Contract #: 04-0120F4Cty: SF/ALA Rte: 80 PM: 13.2/13.9File #: 69.25B**QUALITY ASSURANCE -- NON-CONFORMANCE REPORT****Location:** Changxing Island, Shanghai, P.R. China**Report No:** NCR-000843**Prime Contractor:** American Bridge/Fluor Enterprises, a JV**Date:** 19-Sep-2010**Submitting Contractor:** Zhenhua Port Machinery Company, Ltd (ZPMC), Changxing Island**NCR #:** ZPMC-0805**Type of problem:**

Reference Description: North Tower Lift 3: Missed UT Indication at 89m**Description of Non-Conformance:**

Dear: Mr. Charles Kanapicki
Attention: Mr. Thomas Nilsson Project/Fabrication Manager
Subject: NCR No. ZPMC-0805

Job Name: SAS Superstructure
Document No: 05.03.06-000800

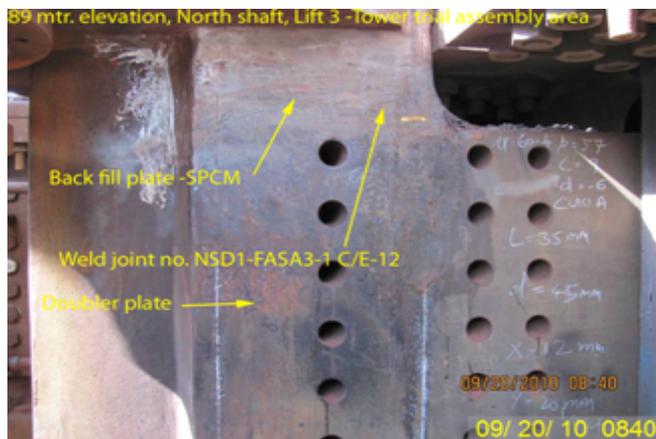
During random 10% verification of Ultrasonic Testing (UT) of Doubler Plate to Backfill Plate, this Quality Assurance Inspector (QA) discovered the following issue:

- One Class "A" non conforming longitudinal indication measuring approximately 35 mm in length found in 89 m elevation of North shaft, Lift3, between Doubler plate and Back fill plate.
- The weld is a complete joint penetration (CJP) Butt joint, and is identified as NSD1 – FASA3-1 C/E – 12.
- The discontinuity rating is Class "A" reject (DB rating -5).
- The back fill plate member is identified as Seismic performance critical member (SPCM)
- Depth of the discontinuity from face A is approximately 45 mm, and Y location found to be 18 mm from Tower Strut side.
- The Material thickness is 50 mm.
- The member is located in Tower Trial assembly area, Heavy Dock Jetty.
- The indication was discovered in an area which had been previously tested and accepted by ZPMC QC UT technicians.
- The NDT Inspection notification Number is 06711.

For further information, please see the attached pictures below.

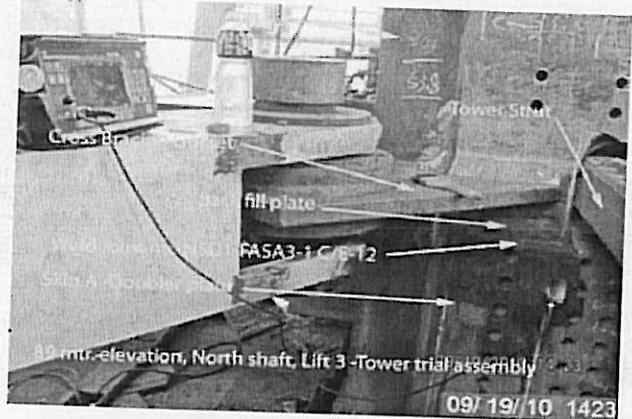
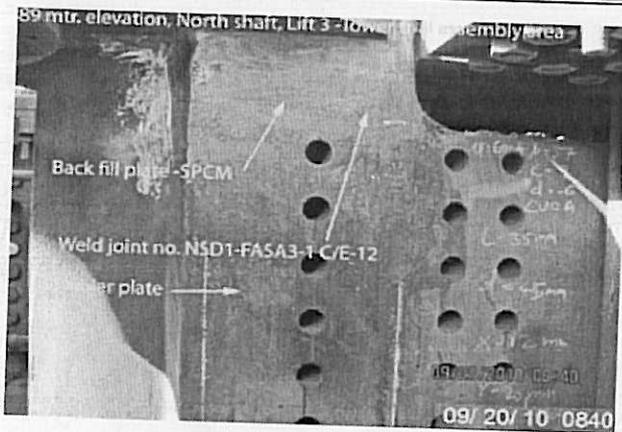
During random 10% verification of Ultrasonic Testing (UT) of Doubler Plate to Backfill Plate, this Quality Assurance Inspector (QA) discovered the following issue:

- One Class "A" non conforming longitudinal indication measuring approximately 35 mm in length found in 89 m elevation of North shaft, Lift3, between Doubler plate and Back fill plate.
- The weld is a complete joint penetration (CJP) Butt joint, and is identified as NSD1 - FASA3-1 C/E - 12.
- The discontinuity rating is Class "A" reject (DB rating -5).
- The back fill plate member is identified as Seismic performance critical member (SPCM)
- Depth of the discontinuity from face A is approximately 45 mm, and Y location found to be 18 mm from Tower Strut side.
- The Material thickness is 50 mm.
- The member is located in Tower Trial assembly area, Heavy Dock Jetty.
- The indication was discovered in an area which had been previously tested and accepted by ZPMC QC UT technicians.
- The NDT Inspection notification Number is 06711.

For further information, please see the attached pictures below.

焊缝编号为：NSD1-FASA3-1C/E-12

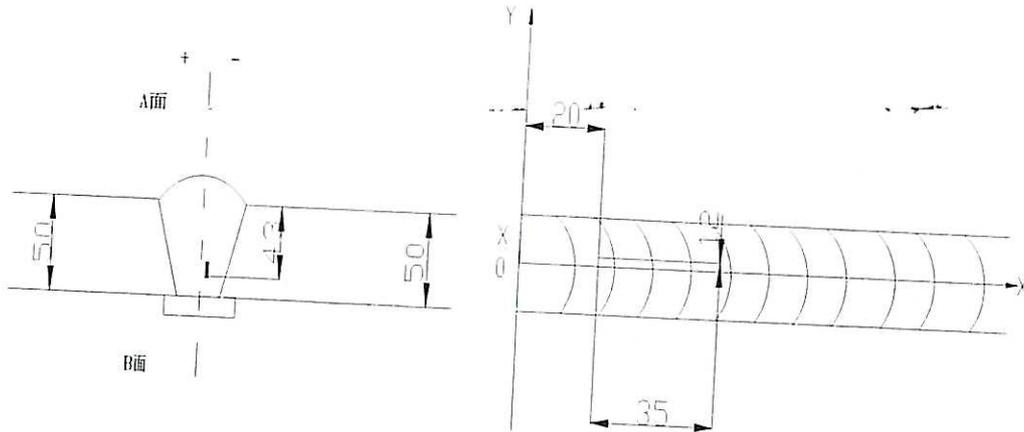
焊缝缺陷描述：(普通UT探伤发现的缺陷长度小于最大允许长度)
(Description of welding discontinuity)

产生原因:

Caused:

1、焊道未及时处理干净。

1. Did not clear the weld pass completely in time.

1. 从缺陷距离端面较近一侧 ($D \leq 0.65T$, D为缺陷深度, T为板厚) 采用碳刨或打磨的方法去除焊缝缺陷;
2. 参照返修焊接工艺规程 (WPS) 准备正确的接头型式, 预热和焊接;
3. 将修补区域打磨到与母材或邻近焊缝平齐;
4. 根据批准的车间图纸检查焊缝.

1. Gouge or grind from nearer side from metal edge ($D \leq 0.65T$, "D" is depth of defects, "T" is thickness of metal) to remove all defects;
2. Follow repair WPS for joint preparation, preheat, and weld deposit;
3. Grind the repaired area flush with base metal or the adjacent weld;
4. Check the welds according to the working drawings.
